ADDENDUM TO THE CONTRACT DOCUMENTS

ADDENDUM NO. 02
	Project: Solano Community College District Early College High School Portables Project Project Number: 20-012
	Date: June 23, 2020

**EARLY COLLEGE
HIGH SCHOOL
PORTABLES**

**SOLANO COMMUNITY
COLLEGE**

AS2

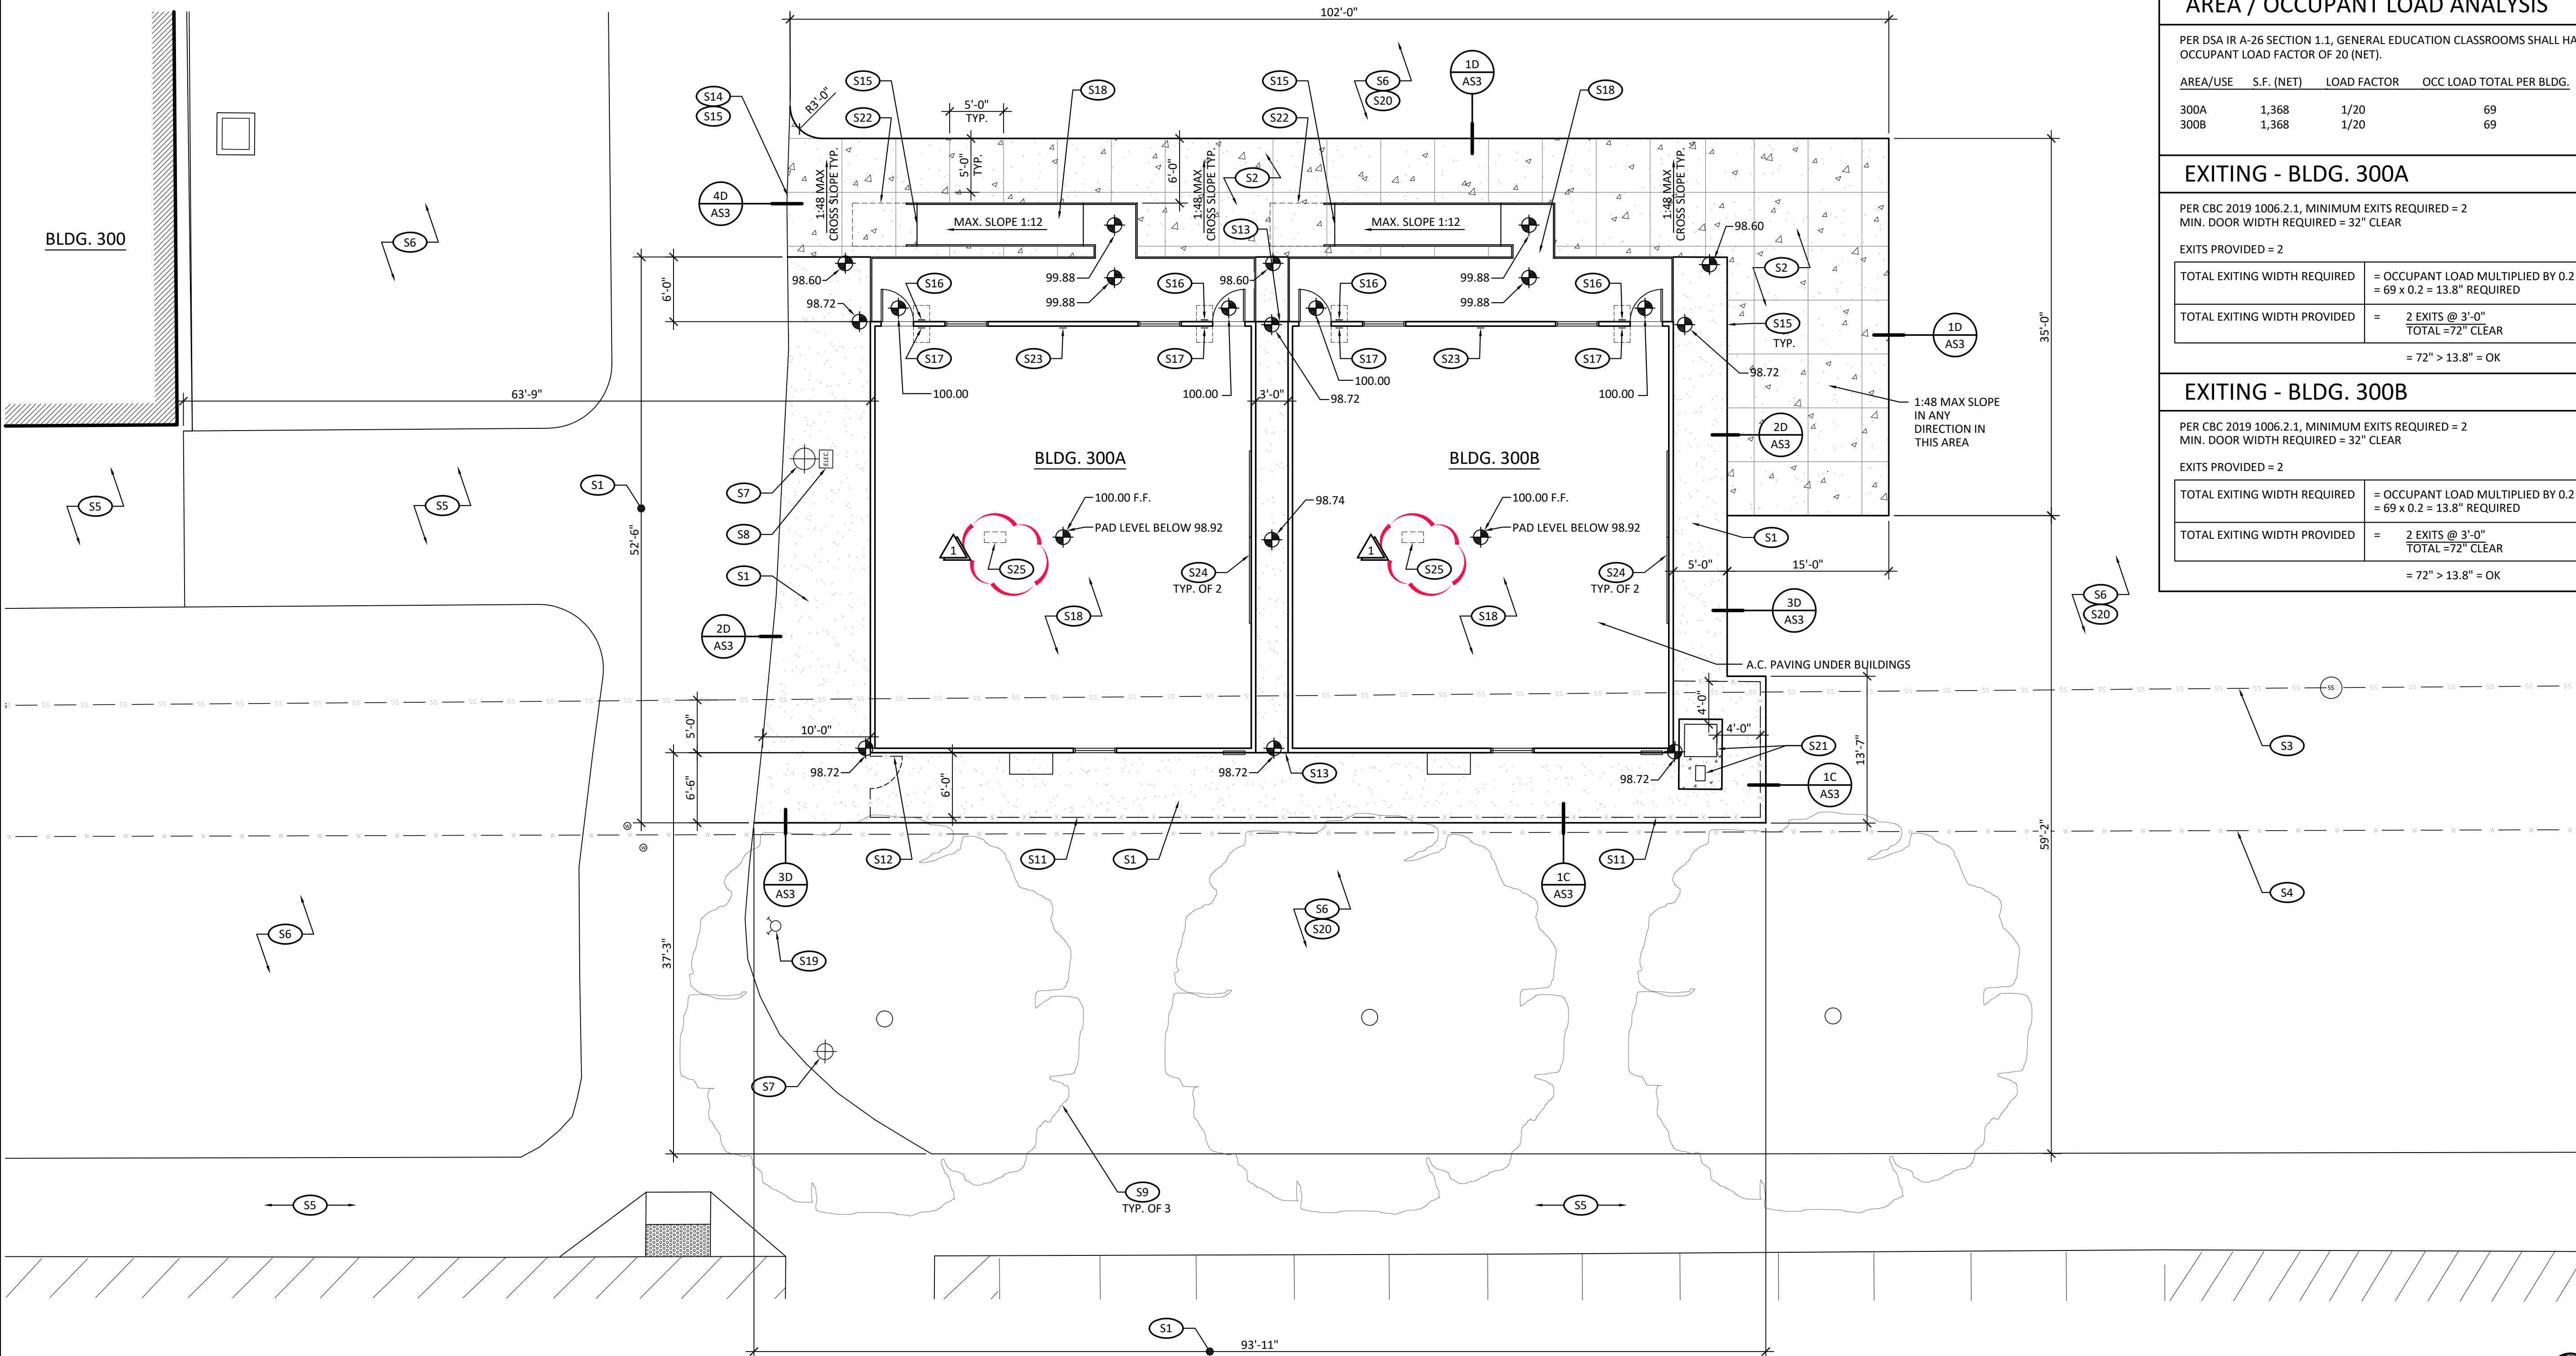
- 1** One projector mount shall be mounted above the ceiling in each classroom. Coordinate Location with the District. The projector mount shall be Peerless-AV CMJ500R1. See sheet AS2 and detail 1B/AS3.

- S24 8'W x 4'H WHITEBOARD. COORDINATE LOCATION WITH DISTRICT. SEE 3B AS3
- S25 PROJECTOR MOUNT ABOVE CEILING. COORDINATE LOCATION WITH DISTRICT. SEE 1B AS3

BUILDING GROUNDING DETAIL

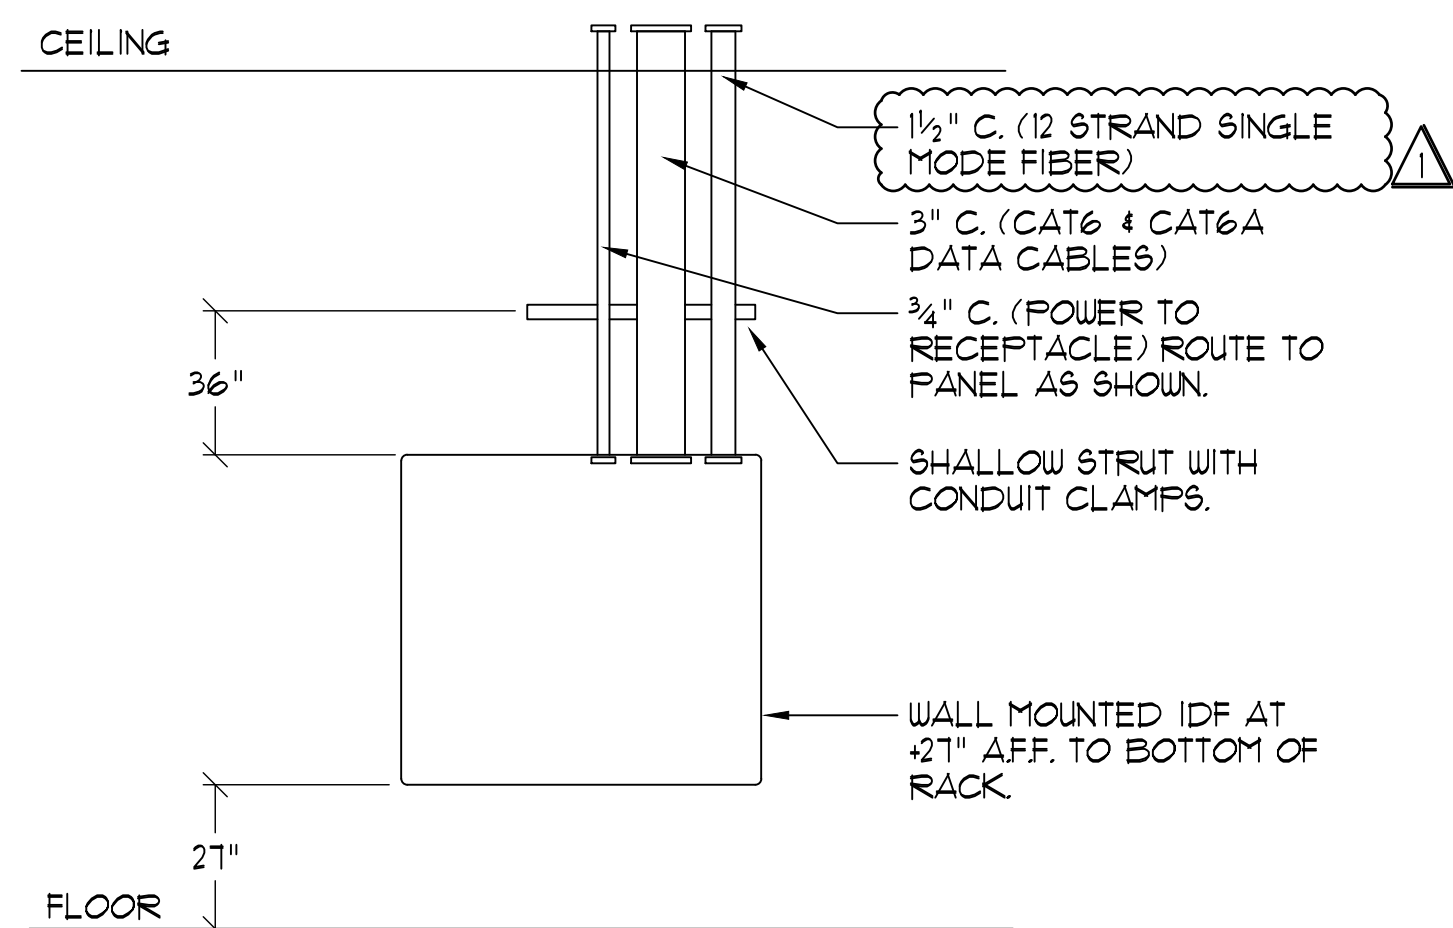
- 2** Revised Building Grounding Detail G, to show building electrical panel as an interior mounted panel. Revised Typ. Conduit to IDF Detail J to show only the 12 strand single mode fiber optic cable in 1-1/2" conduit. See sheet E1.2.

- SIZE OF CONDUCTORS SHALL COMPLY WITH 2019 C.E.C.
- BOND TO SEPARATE CONDUCTORS FROM GROUND ROD TO ELECTRICAL PANEL, METAL BUILDING FRAME & RAMP (2019 C.E.C.). GROUND TO METAL WATER PIPE EMBEDDED AT LEAST 10'-0" INTO THE SOIL IF AVAILABLE (C.E.C. 2019 EDITION).
- ALL MODULES OF METAL FRAME BUILDING SHALL BE ELECTRICALLY BONDED TOGETHER (BOLTING ONLY IS NOT ACCEPTABLE BONDING).
- CHECK RESISTANCE TO GROUND. IF RESISTANCE EXCEEDS 25 OHMS, INSTALL ADDITIONAL GROUND RODS WITH CONDUCTORS AS SHOWN SEPARATED AT LEAST 6'-0" UNTIL RESISTANCE IS REDUCED TO 25 OHMS OR LESS (C.E.C. 2019 EDITION).
- PROVIDE GAS AND WATER BOND.
- SITE INSPECTOR OF RECORD SHALL WITNESS AND VERIFY ALL TESTING.

FIRE ALARM SCOPE OF WORK

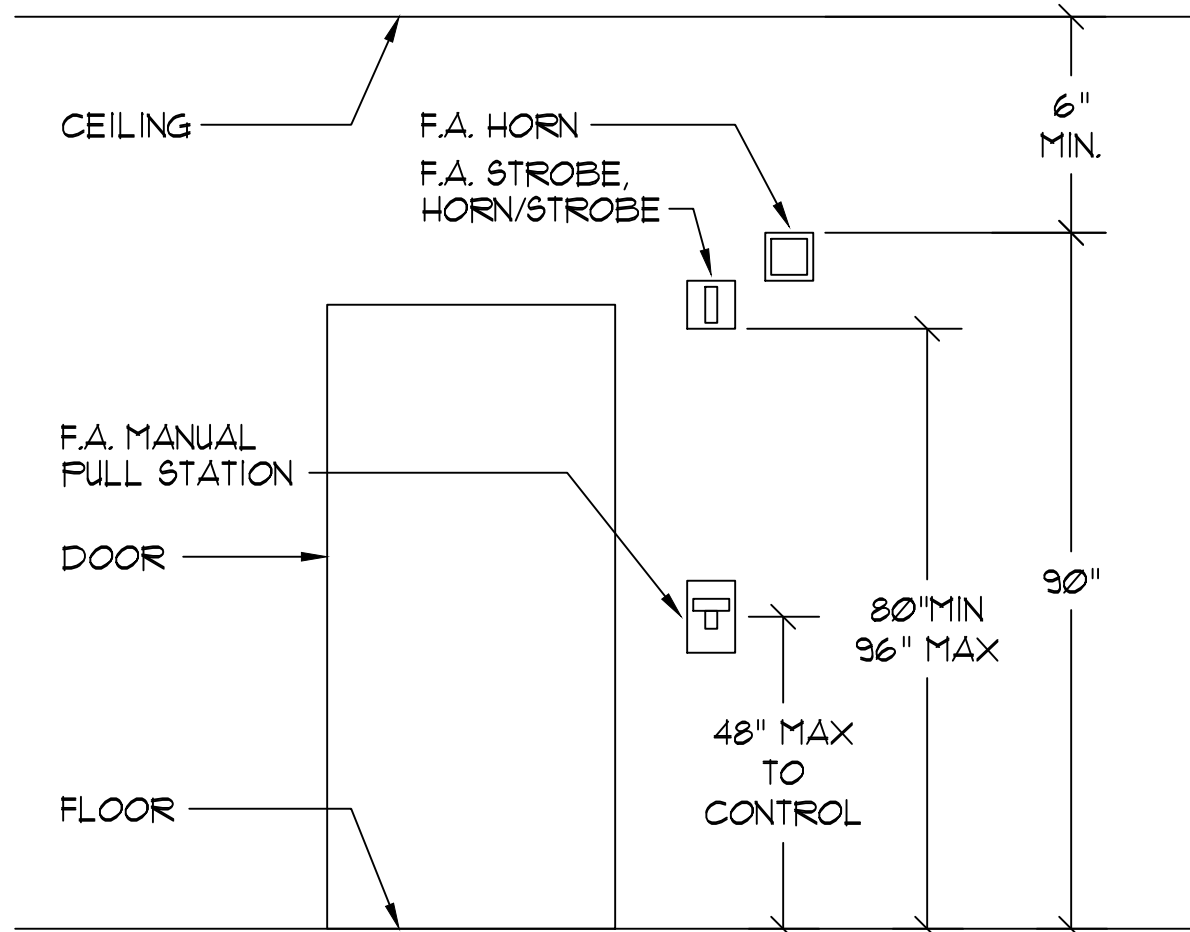
- 3** Revised Fire Alarm Scope of Work. See sheet E1.3.
- 4** Revised Numbered Notes 11 and 13 to have 1" inner duct in lieu of 1-1/2". Added to Numbered Note 6 to direct contractor to x-ray the concrete slab and coordinate conduit routing in field with General Contractor (G.C.), Construction Manager (C.M.) and College District Electrical Department. See sheet E2.0.

THE COLLEGE IS GETTING (2) NEW 36" X 40" PORTABLES WITH A NEW FIRE ALARM VOICE EVACUATION SYSTEM. CONTRACTOR SHALL PROVIDE AND INSTALL A NEW FIRE ALARM SYSTEM FOR A COMPLETE & OPERATIONAL INSTALLATION.

ENLARGED POWER PLAN
SCALE: 1/8" = 1'-0"

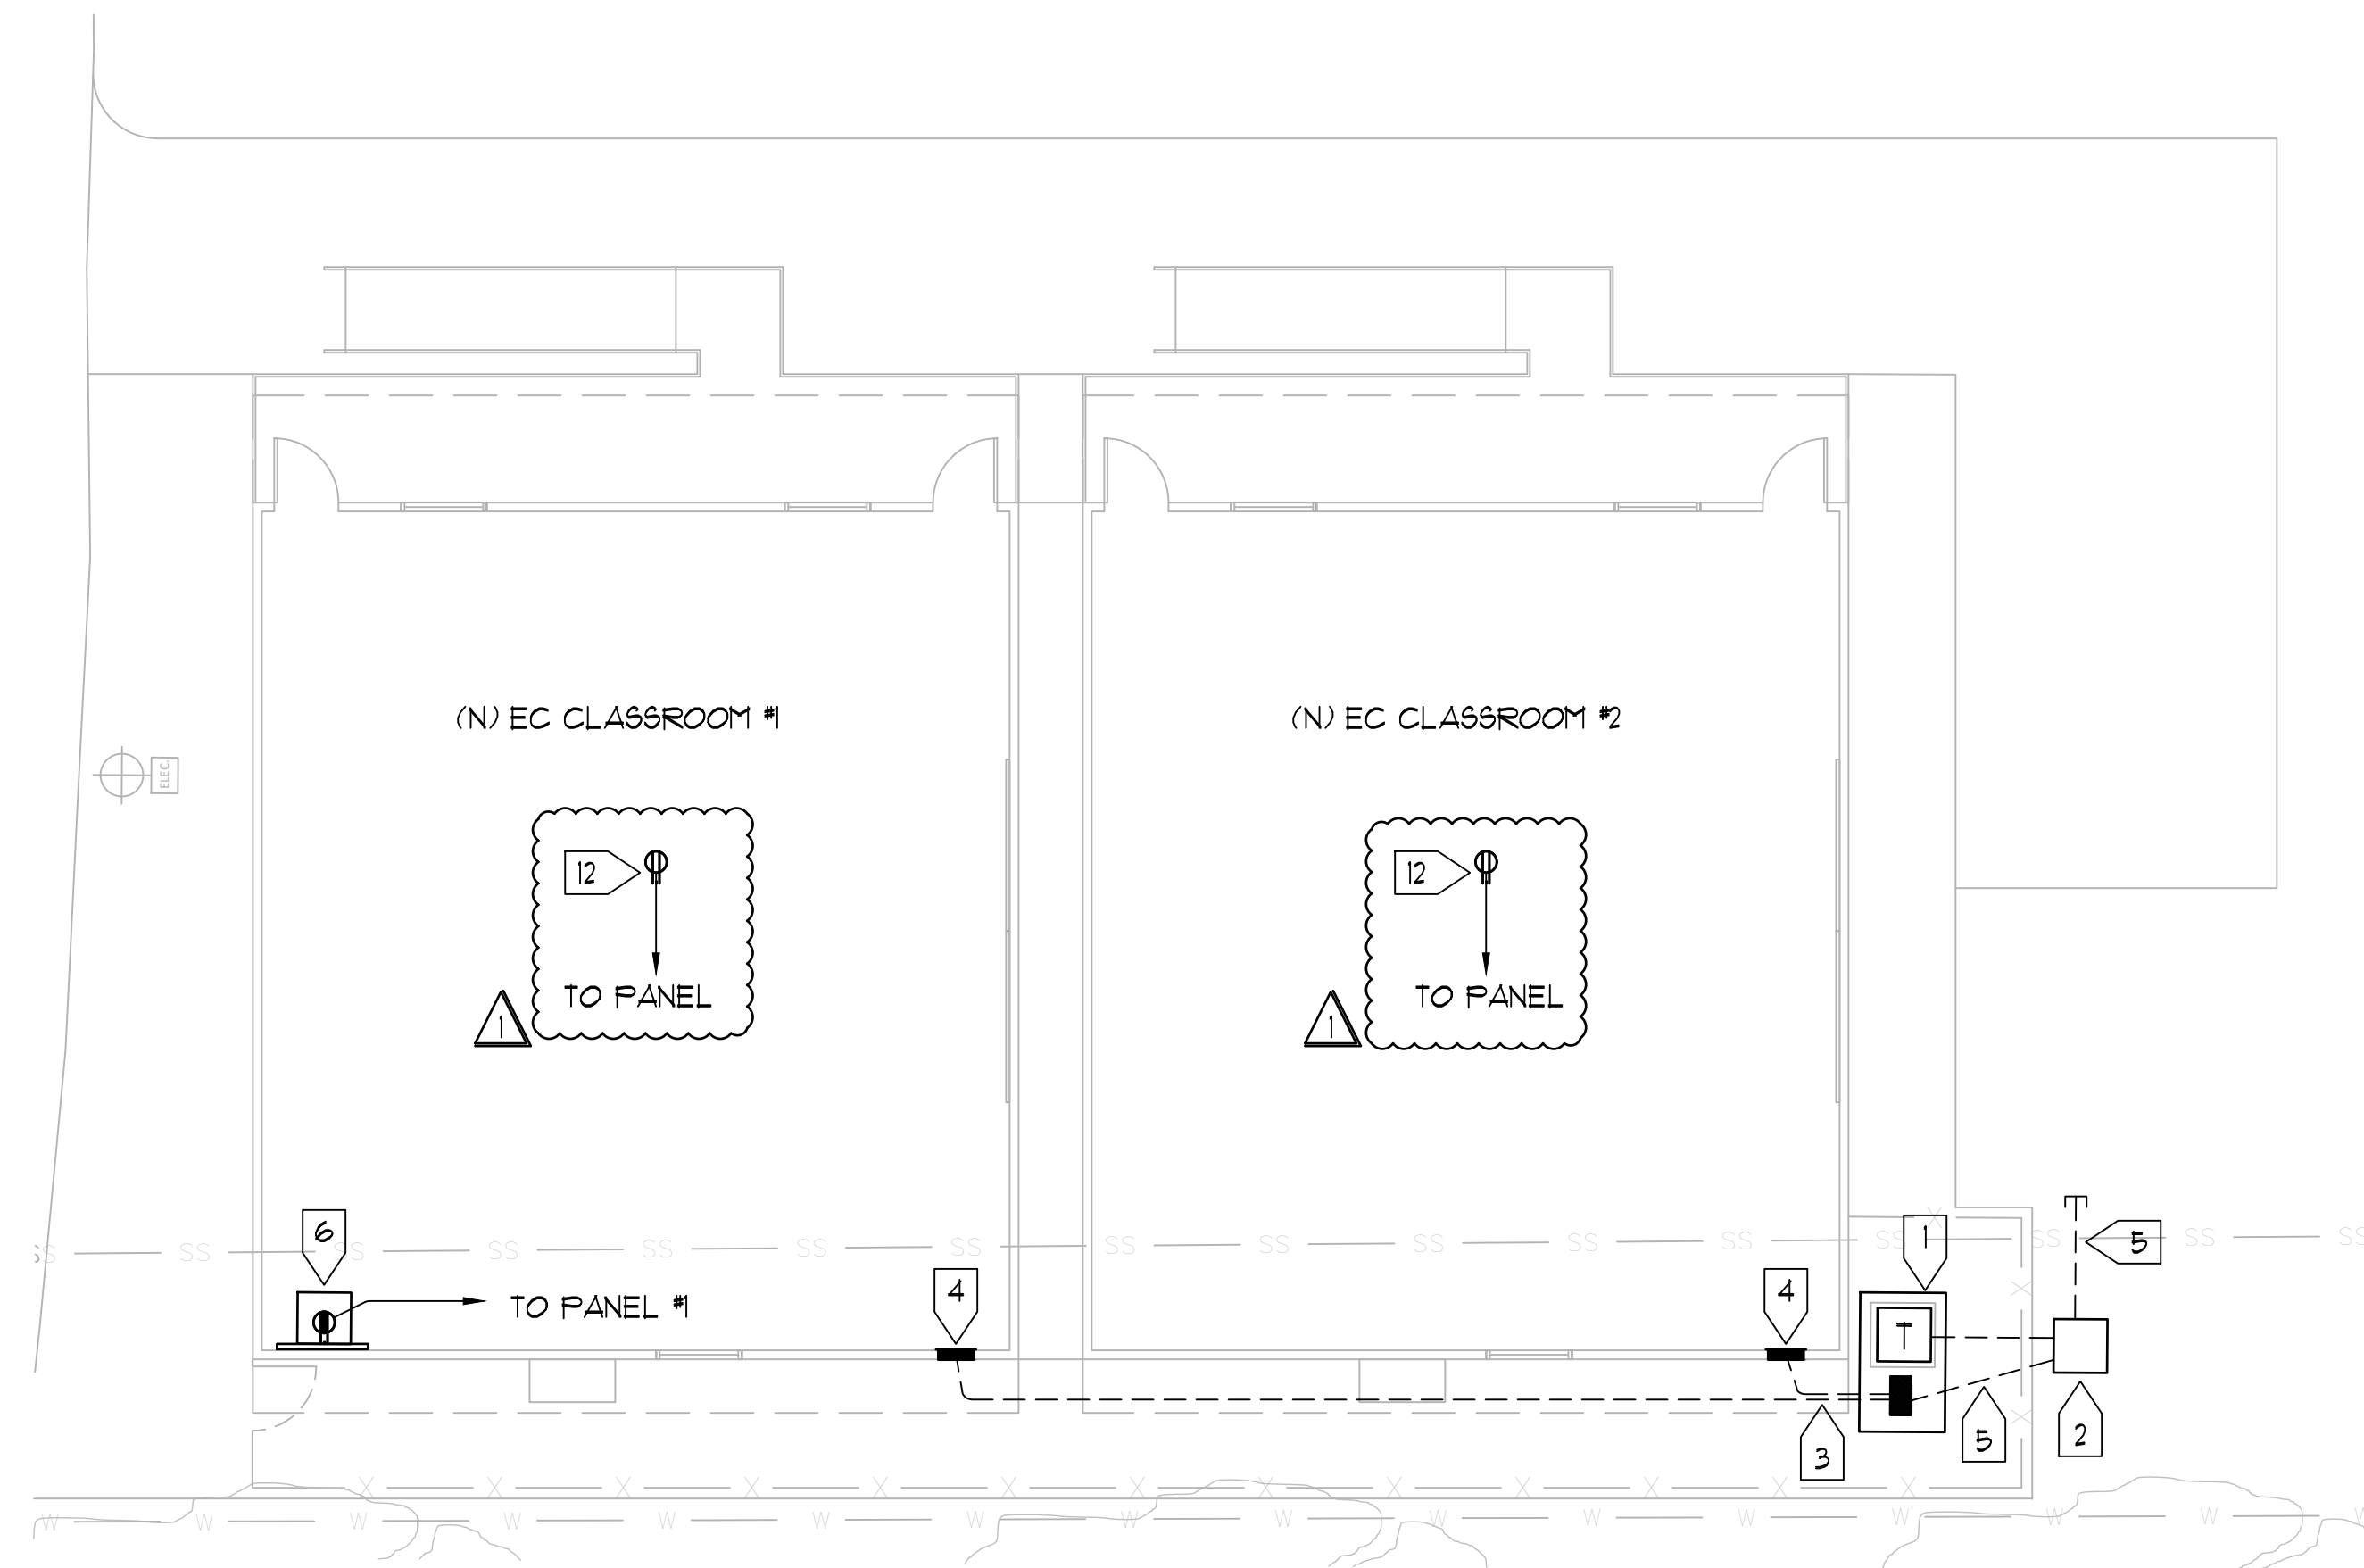
- 5** Revised Enlarged Power Plan A/E3.0. Added a ceiling receptacle for a projector in each Portable Classroom and added Numbered Note 12. Revised Numbered Note 4 informing contractor to install a 20 amp, 120 volt, 1 phase in electrical panel for projector. Revised Numbered Note 6 informing the contractor to provide new IDF cabinet, fan kit and install on plywood backboard per detail C/E1.1. Revised Enlarged Signal Plan B/E3.0. Revised ceiling data cabling to (2) CAT6A cables in lieu of (1) CAT6 and (1) CAT6A cable. Revised the number of data cables at the back of the classroom, on the East and West walls to (4) data cables in lieu of (2) data cables per

3. ELECTRICAL FEEDER FROM DPI TO EACH PORTABLE BUILDING ELECTRICAL PANEL. SEE ONE LINE DIAGRAM A/E11 FOR SIZE & QUANTITY OF CONDUIT AND CONDUCTORS.
4. PORTABLE ELECTRICAL PANEL. PANEL IS SUPPLIED WITH THE BUILDING. PROVIDE A 120 VOLT, 1 PHASE, 20 AMP CIRCUIT BREAKER AND INSTALL IN PANEL SPACE FOR CEILING PROJECTOR RECEPTACLE. CONTRACTOR TO CONNECT FEEDER TO PANEL AND GROUND PANEL PER DETAILS F & G/E12 FOR A COMPLETE AND OPERATIONAL INSTALLATION.

12. MOUNT RECEPTACLE ABOVE CEILING FOR POWER TO PROJECTOR. ROUTE CIRCUIT TO BUILDING ELECTRICAL PANEL AND CONNECT TO 20 AMP RECEPTACLE FOR A COMPLETE AND OPERATIONAL INSTALLATION.
